UNITED STATES
NUCLEAR REGULATORY COMMISSION
WASHINGTON, D. C. 20555

BRUNSWICK STEAM ELECTRIC PLANT, UNIT NO. 2

Amendment No. 14
License No. DPR-62

ATTACHMENT TO LICENSE AMENDMENT NO. 14

FIG. NO. 3.1-2A

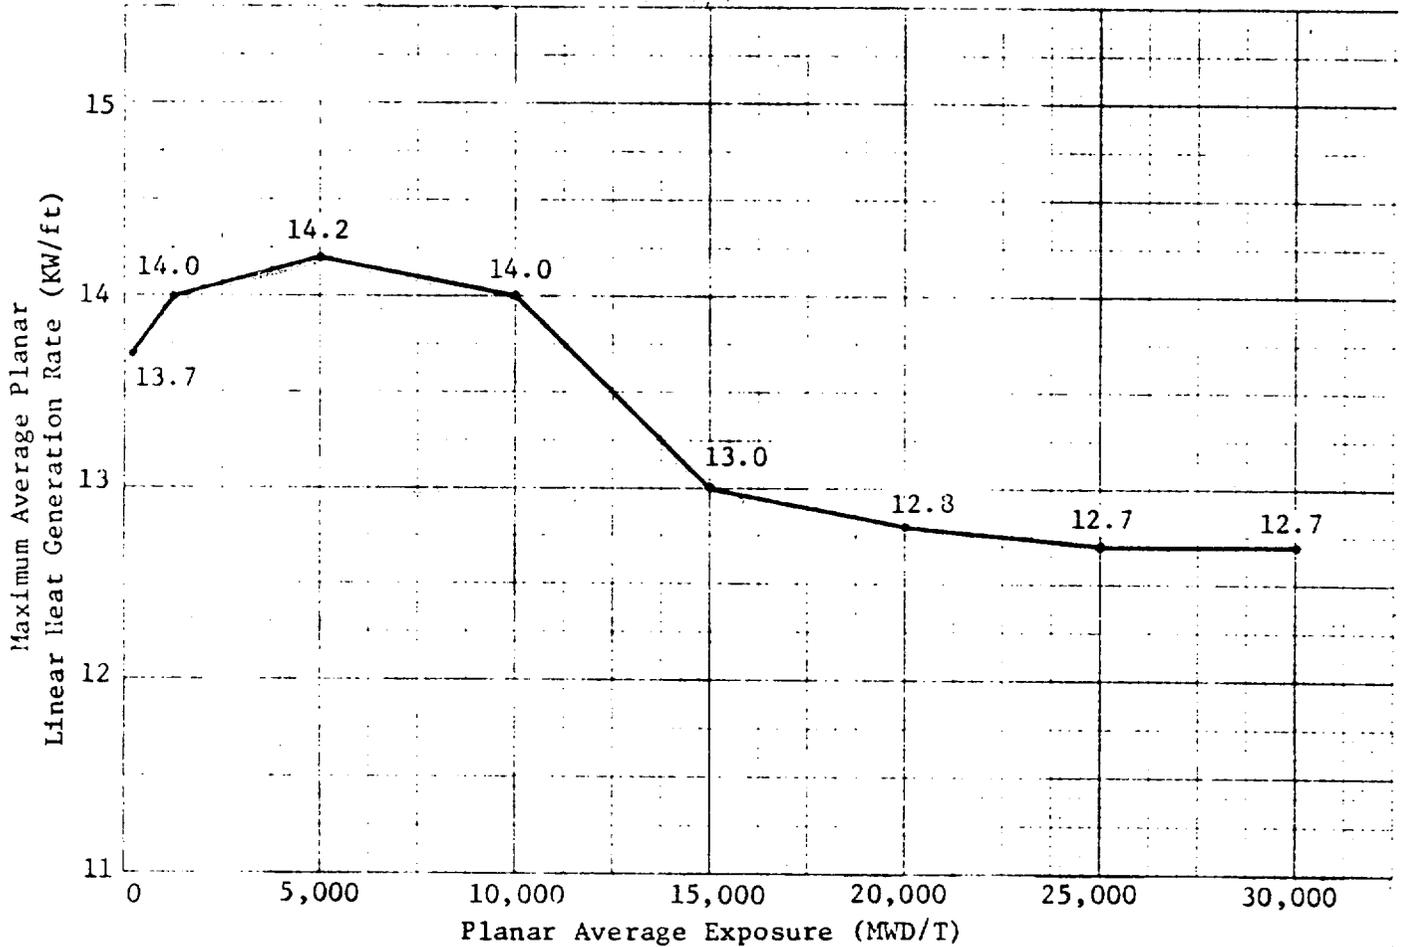
1. Remove the following pages and replace with identically numbered revised pages:
 - 1.1-3 and 1.1-4
 - 1.1-5 and 1.1-6
 - 1.1-9 and 1.1-10
 - 1.1-11 and 1.1-12
 - 1.1-17 and 1.1-18
 - 3.1-1 and 3.1-2, 3.1-5 and 3.1-6
 - 3.1-13 and 3.1-14
 - 3.1-17 and 3.1-18
 - Fig. 3.1-2A and Fig. 3.1-2B
2. Add new Fig 3.1-2C

**MAXIMUM AVERAGE PLANAR LINEAR HEAT
 GENERATION RATE (MAPLHGR) VERSUS
 PLANAR AVERAGE EXPOSURE
 7x7-Plugged Core Plate**

FIG. NO. 3.1-2B

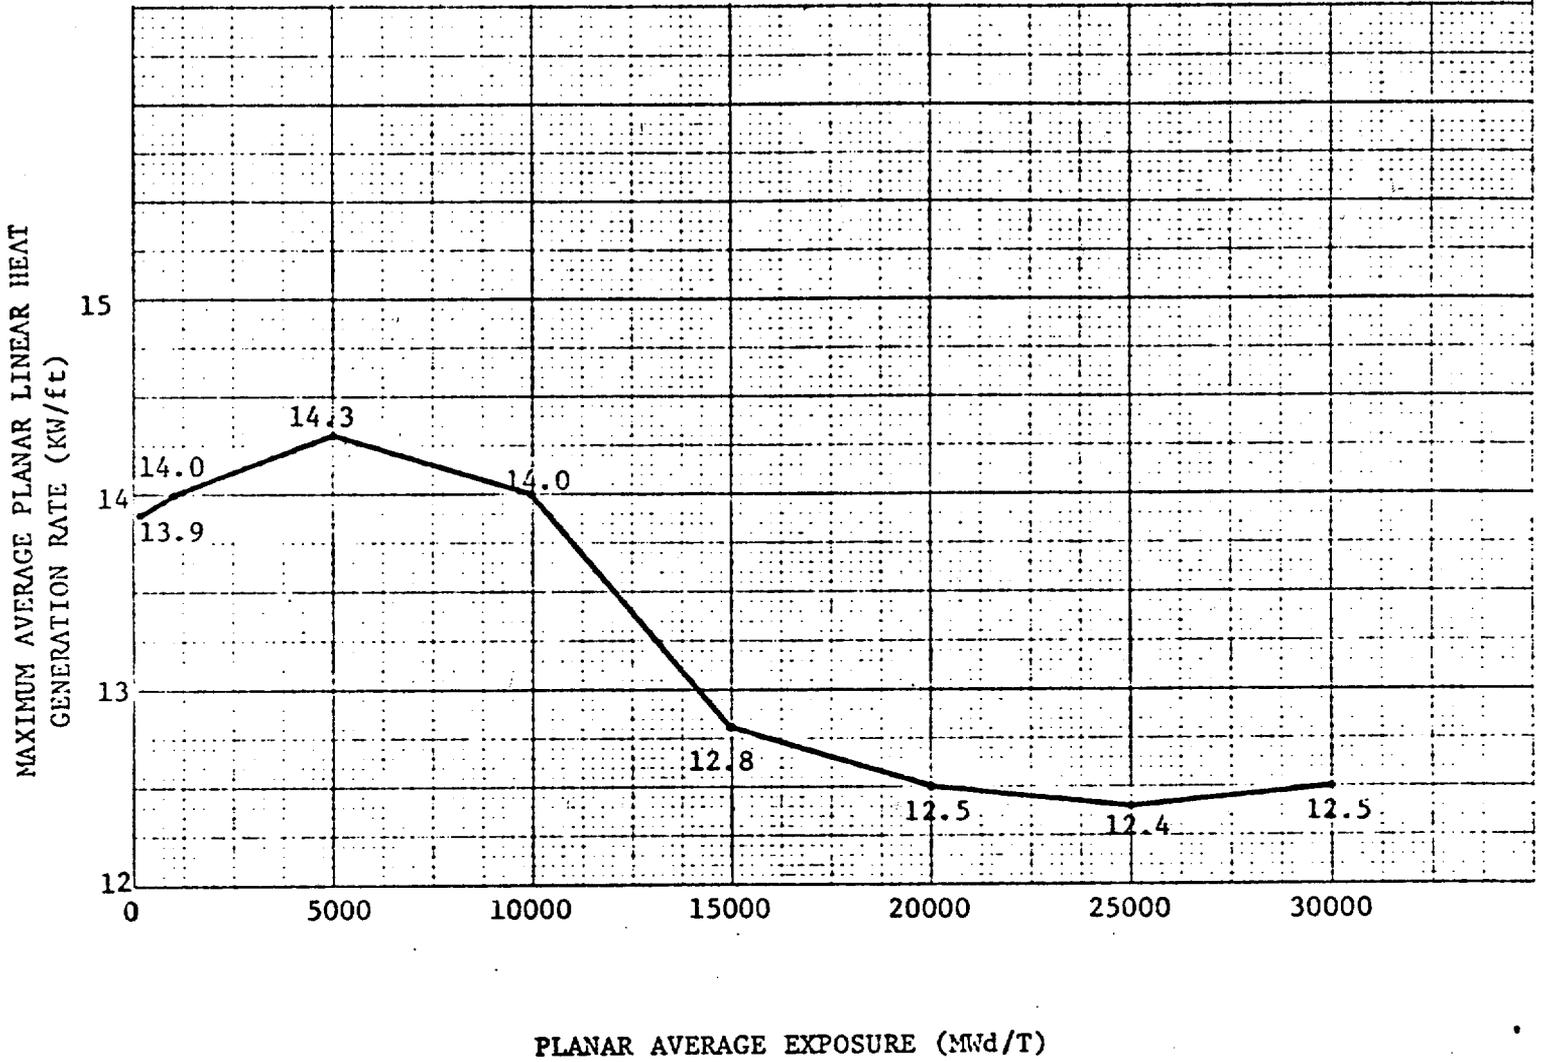
INITIAL CORE FUEL TYPE 2

The applicant submitted acceptable additional LOCA analyses for the four replacement fuel bundles used to replace the four damaged fuel bundles. MAPLHGR limits for those bundles are given in Figure 3.1-2C of reference 6.

Limitations on the continued operation of the reactor for the remainder of Cycle 1 are presented below. Operation shall conform to a MCPR value of 1.28, as proposed by the licensee.⁽¹⁾ The limiting values of MAPLHGR included with the proposed Technical Specifications submitted (attachment B of reference 1) properly account for the proposed operation with plugged bypass holes. The revised values are given in Figures 3.1-2A and 3.1-2B.⁽¹⁾ The limiting MAPLHGR for the four replacement fuel assemblies is given by Figure 3.1-2C of reference 6.

The peak cladding temperature following a postulated loss-of-coolant accident is primarily a function of the average heat generation rate of all the rods of a fuel assembly at any axial location and is only dependent secondarily on the rod to rod power distribution within an assembly. Since expected local variations in power distribution within a fuel assembly affect the calculated peak clad temperature by less than $+20^{\circ}\text{F}$ relative to the peak temperature for a typical fuel design, the limit on the average linear heat generation rate is sufficient to assure that calculated temperatures are within the 10CFR50 Appendix K limit. The limiting value for APLHGR is shown in Figure 3.1-2A for fuel types 1 and 3, Figure 3.1-2B for fuel type 2 and Figure 3.1-2C for the interim replacement fuel assemblies.
